MAJOR PROJECT ASSESSMENT:
Mixed Use Development, 147 Soldiers
Point Road, Soldiers Point
(06_0183)

Director-General's
Environmental Assessment Report
Section 75I of the
Environmental Planning and Assessment Act 1979

August 2011

Figure 9: Proposed development from viewpoint A

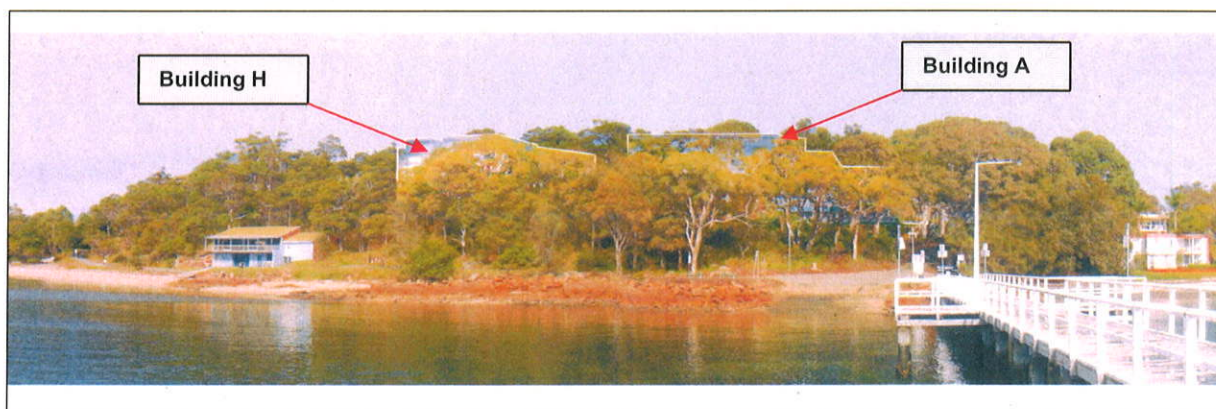
Figure 9 illustrates the visual impact from Viewpoint A. The vegetation in the public reserve significantly screens the development from this viewpoint. The upper floors of the buildings protrude above the canopy, but are not visually dominant or significantly more visible than the existing hotel.

Figure 10: Photomontage from viewpoint B

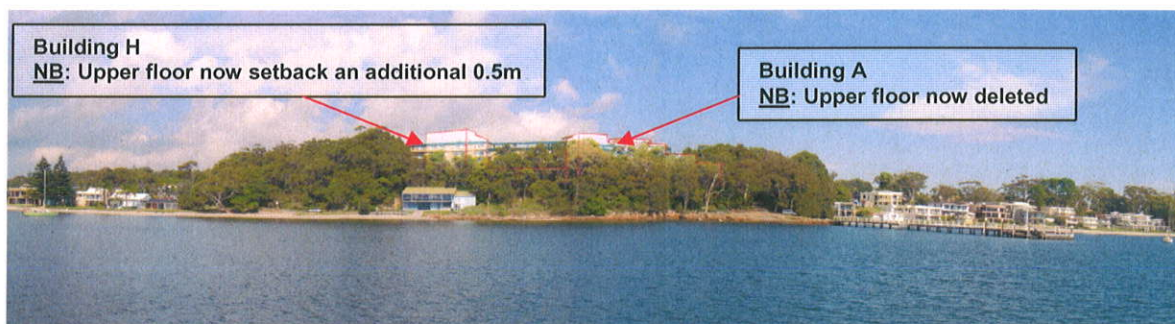
The tree canopy dips at the midpoint of the eastern boundary making Building H more prominent when observed from Viewpoint B (refer to **Figure 10**). The existing hotel has an elongated and unrelieved form from this viewpoint. The proposed development has two building envelopes (Building H) and (Building A) separated by 32m (approx). The separation provides relief in the built form and an improved visual outcome when compared to the existing building.

Figure 12: Photomontage and artist's impression looking south east from Soldiers Point Road

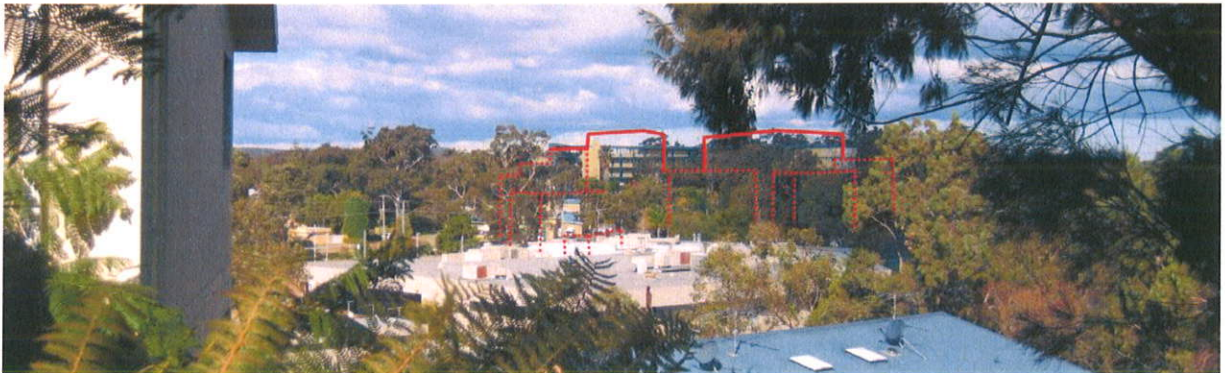
Figure 12 shows the proposed development from the north. Building C is setback 1 metre from the northern boundary and is three storeys in height. It has been placed to activate the street edge. The height of the building is acceptable for a street edge in a commercial zone. Its visual impact will be mitigated by the existing screening vegetation.
